Docket Number:	18-IRP-01
Project Title:	Integrated Resource Plan
TN #:	229902
Document Title:	Staff Paper - Review of Silicon Valley Power's 2018 Integrated Resource Plan
Description:	N/A
Filer:	Courtney Wagner
Organization:	California Energy Commission
Submitter Role:	Commission Staff
Submission Date:	10/1/2019 3:48:48 PM
Docketed Date:	10/1/2019

Review of Silicon Valley Power's 2018 Integrated Resource Plan

September 2019 | CEC-200-2019-017

Figure 1: Silicon Valley Power and California Energy Commission Energy Forecasts 2017-2030 (GWh)

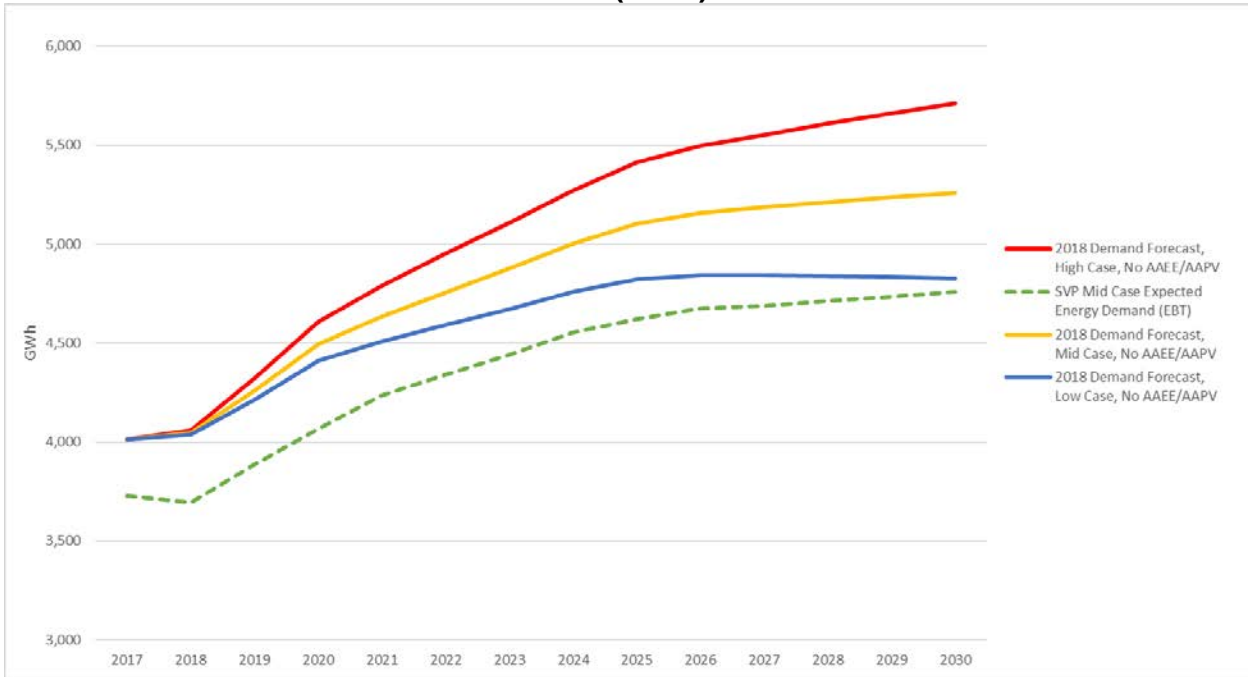
A comparison of SVP's forecasts of energy and peak demand to the CEC's *2018 Demand Forecast Update* is shown in **Figure 1** and **Figure 2**, respectively. SVP's expected growth scenario for energy starts below the CEC's low-demand case with no AAEE and AAPV, but increases over the forecast period to nearly the same level as the CEC's low-demand case with no AAEE and AAPV by 2030.⁷

Figure 2: Silicon Valley Power and California Energy Commission Peak Demand Forecasts 2018 — 2030 (MW)

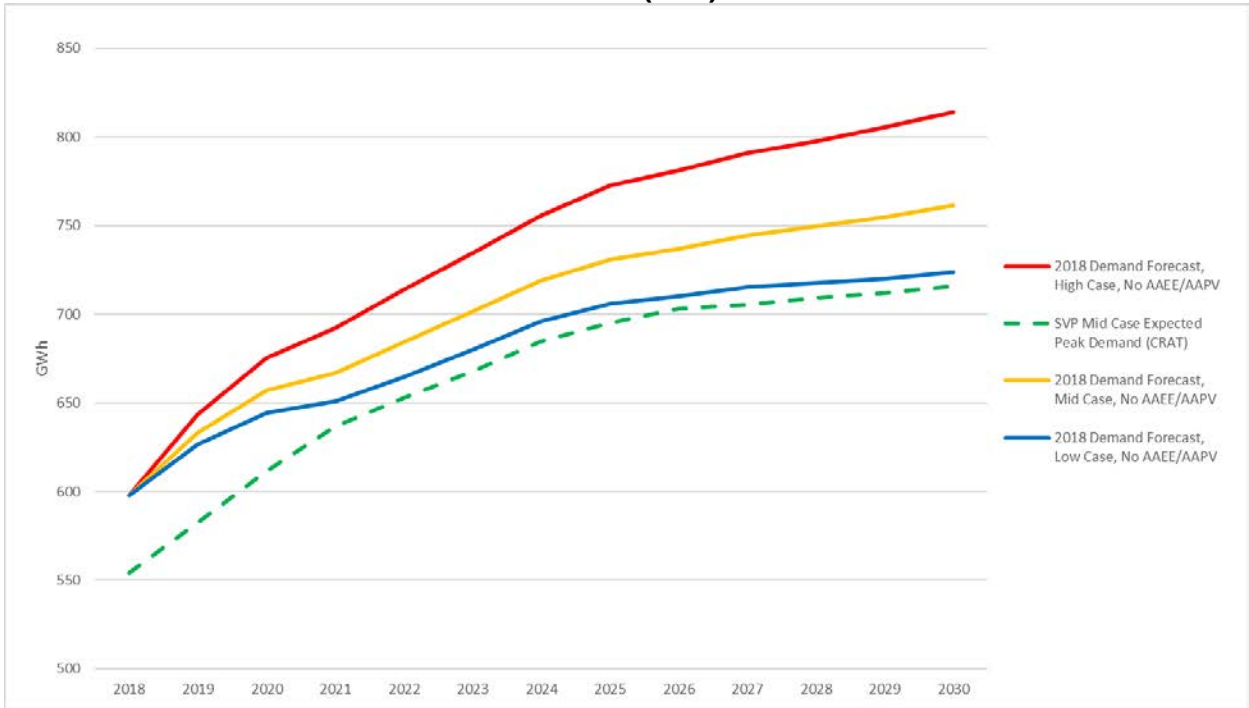
SVP's expected growth scenario for peak demand also starts below the CEC's low-demand case with no AAEE and AAPV, but increases to nearly the CEC's low-demand case with no AAEE and AAPV by 2021, then stays just below this case through 2030. This increase in peak demand may be attributed to information

garnered from SVP's engagement with key customers concerning the impact and timing of new energy demand.
